# SERVICE BULLETIN

Ref. AN-027

**Subject: AGC TERMINALS OF THE FM PACK F-1085**  
**Model: 5000A, 5000X, Eight, TU-999**

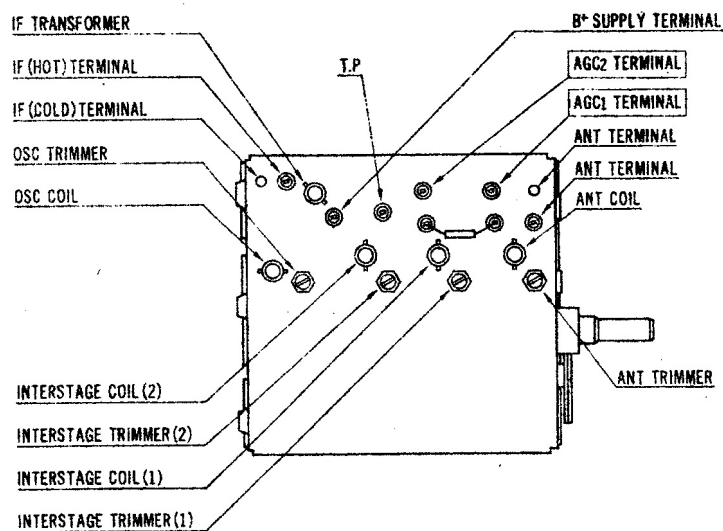
Location of the AGC terminals on some FM packs is different from the others, however, their electrical characteristics are the same.

When replacing the FM pack, refer to the following terminal location.
